Subject: Arkansas Nuclear One - Unit 1
Docket No. 50-313
License No. DPR-51
Request for Information Concerning
Inservice Inspection of Reactor
Coolant Pump Flywheels for Arkansas
Nuclear One, Unit No. 1

ATTACHMENT TO 1CAN118205

REQUEST FOR INFORMATION
CONCERNING
ISI OF RCP FLYWHEELS
FOR
ARKANSAS NUCLEAR ONE, UNIT NO. 1

FIGURE 1 TO 1CAN118205

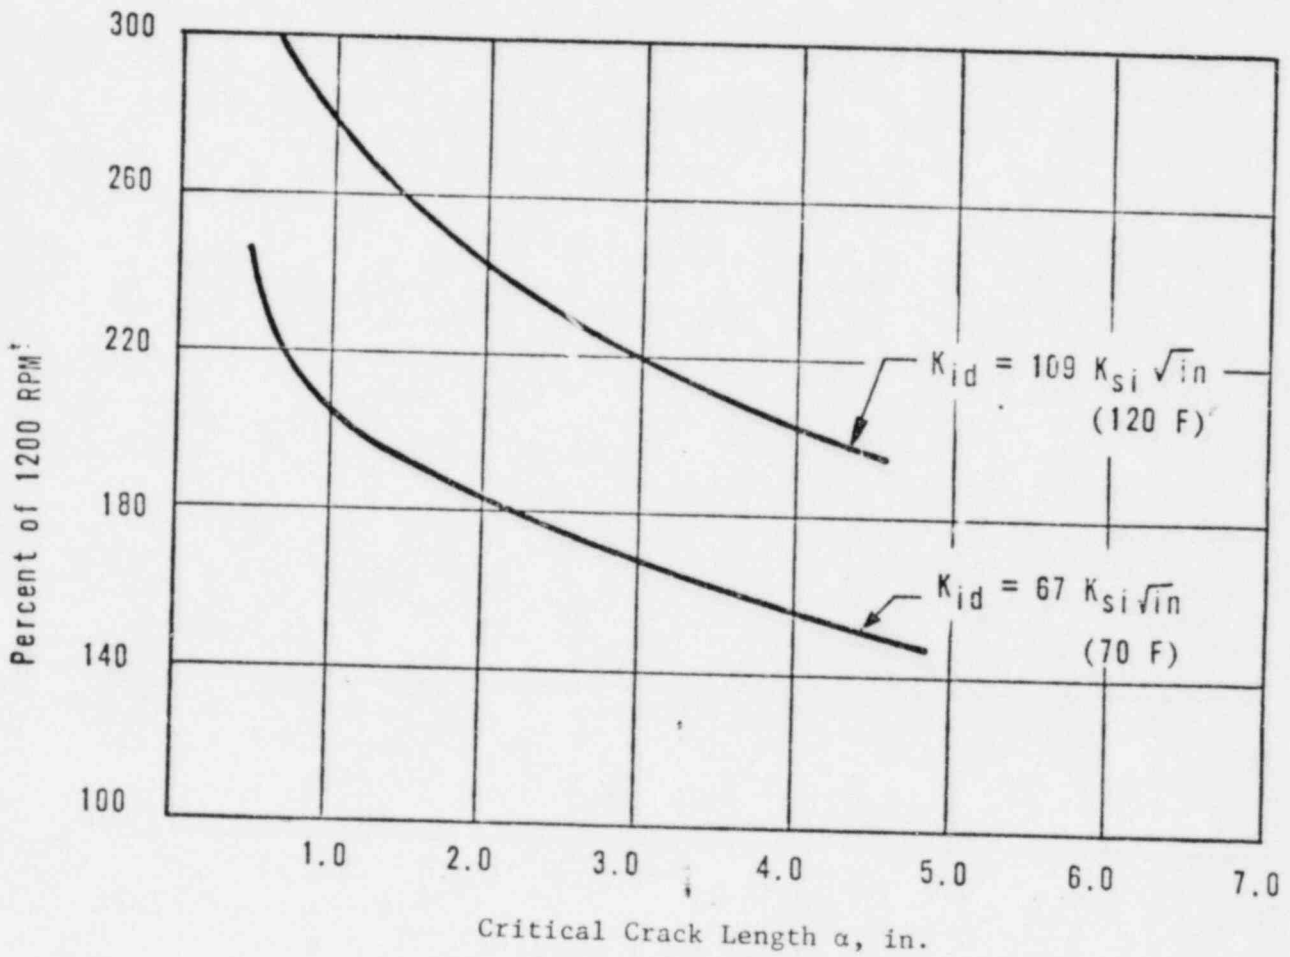
"What is the calculated critical flaw size as a result of flywheel overspeed during a postulated LOCA transient?"

Figure 1 shows the critical crack length in the keyway area of the flywheel at two dynamic fracture toughness (K_{I_d}) values as a function of flywheel speed.

The operating temperature of the flywheel is between 70°F and 120°F which corresponds to temperatures between 80°F and 130°F above the RT_{ndt} of the flywheel plate. At these temperatures, it was calculated (see our Topical

Report BAW-10040 December 1973) that the lower bound dynamic fracture toughness values for the flywheel material at the normal operating temperature are between 67 ksi $\sqrt{\text{in.}}$ and 109 ksi $\sqrt{\text{in.}}$

FIGURE 2 TO 1CAN118205

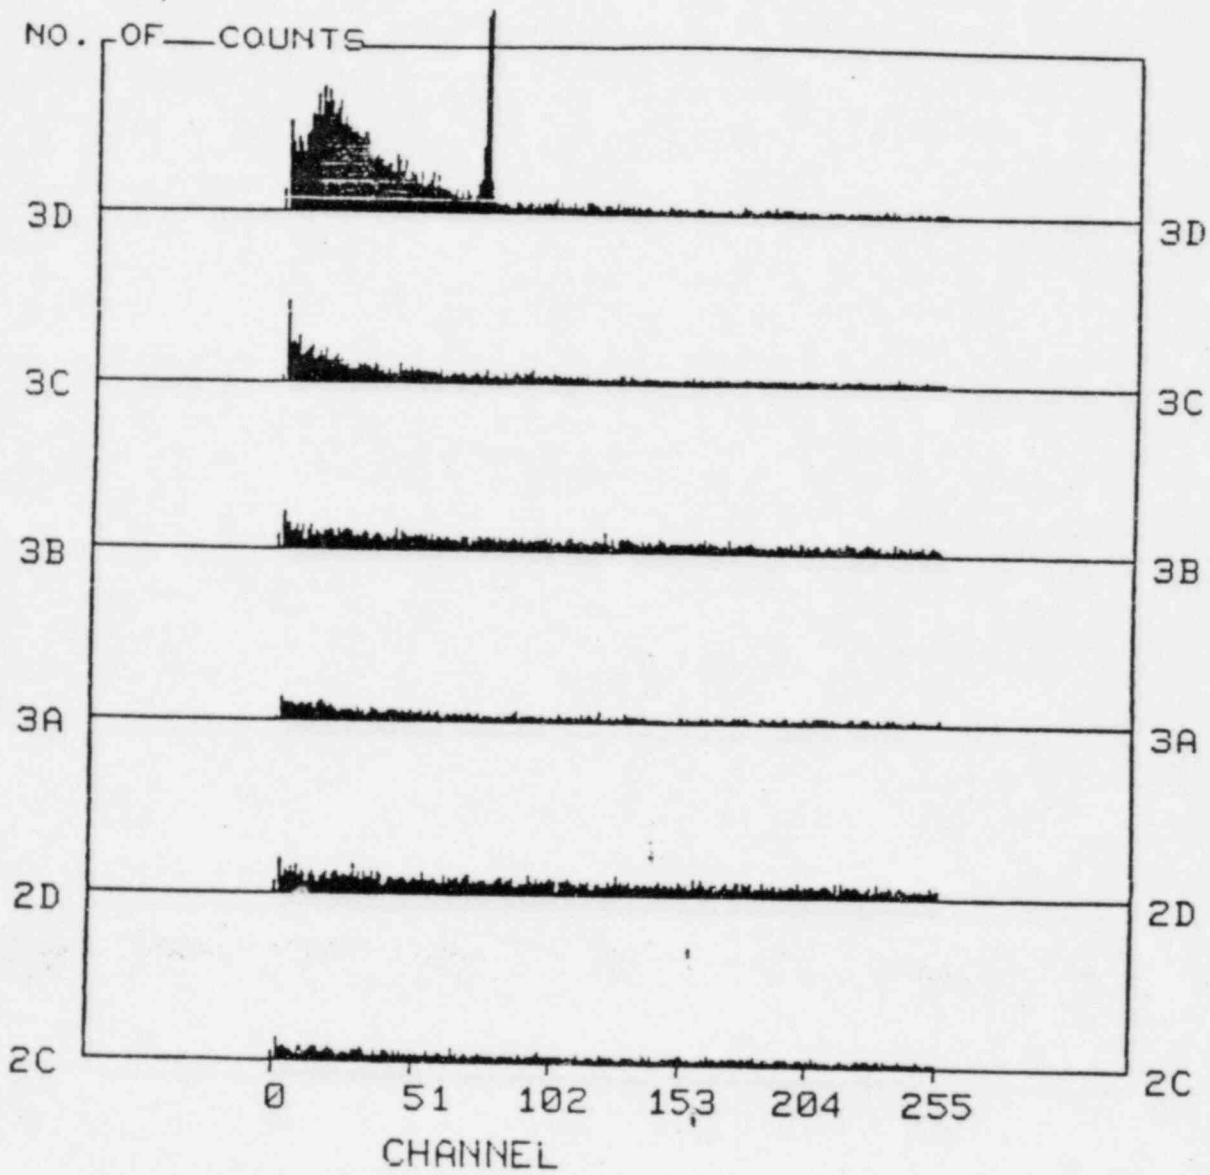
"Describe the acceptance/rejection criteria in terms of Severity Index. Estimate the maximum flaw size that could exist in the keyway area if the lowest Severity Index is produced during the test. Provide a qualitative estimate of the flaw size that must be detected by acoustic emission before supplemental examinations would be performed."

Crack progression measurement is determined by the rate of acoustic energy output from the defect area. As the crack progresses, it releases increasing amounts of acoustic energy. This energy, as processed by the ATP energy scaler, is registered in the ATP memory and utilized by the ECHO and HOTSPOT computer programs for determining defect severity.

In addition, changes in the energy release rate will be documented on a chart recorder for operator recognition and cognizance.

Figures 2 and 3 show these two functions for growing cracks in structures.
